CAMPAIGN 5593 - Recall Campaign

Model: Fiat Ducato all models

- U-bolts fixing the leaf spring to the rear axle

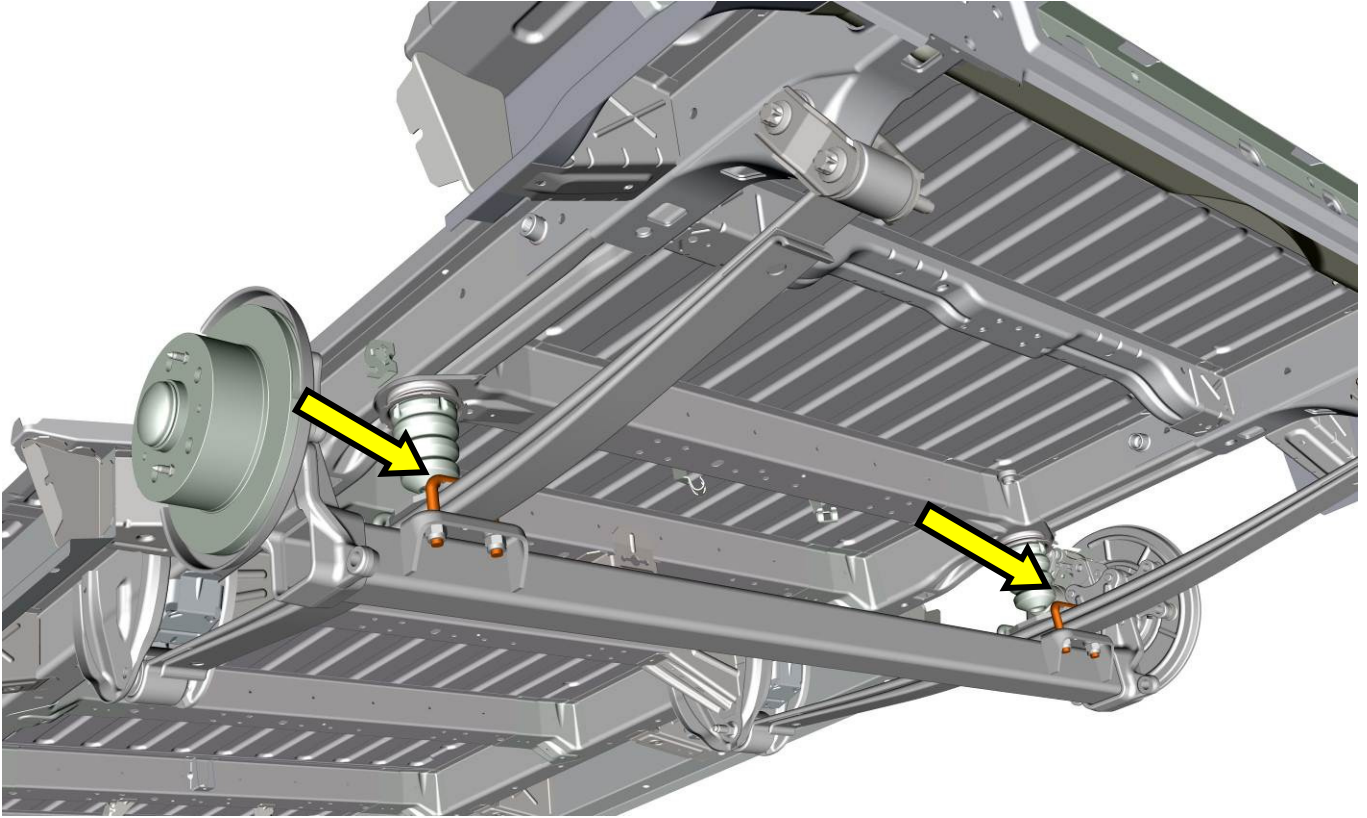
- Position the vehicle on the lift.
- Identify the left and right U-bolts fixing the leaf spring to the rear axle.

- Remove the left and right U-bolts fixing the leaf spring to the rear axle.
- Replace the right and left U-bolts of the rear suspension checking the version (Light or Heavy) where the operation is to be carried out (see Part&Service availability).
- Replace the nut, the flat washer and the tapered washer (see Part&Service availability), as shown.
